| Model: Adonis-C2 PT1045 | | Date: 14-Sep-01 | No.: MB376001 |
| Modified Article: Left Guide Plate - Middle | | Prepared by: E. Fukuyama | |
| From: Technical Services Dept., GTS Division | | | |

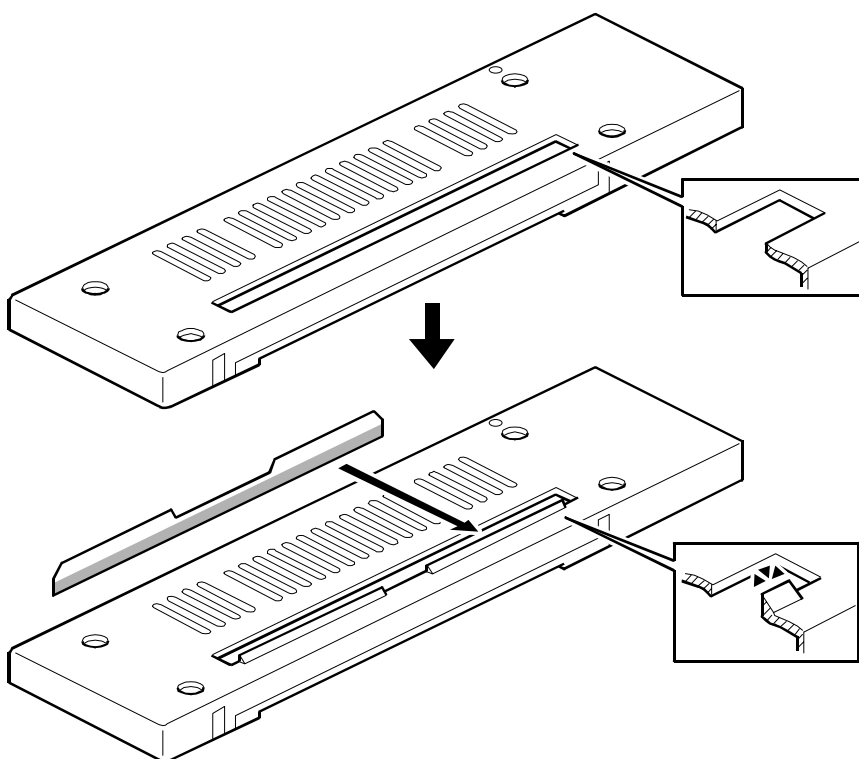
To further ensure that the Middle Left Guide Plate stays securely attached, the width of the boss has been increased from 6 mm to 9 mm.

| Old part number | New part number | Description | Q'ty | Int | Page | Index | Note |
|-----------------|-----------------|---------------------------|------|-----|------|-------|------|
| A6842211 | B3762211 | Left Guide Plate - Middle | 1-1 | X/O | 5 | 20 | |
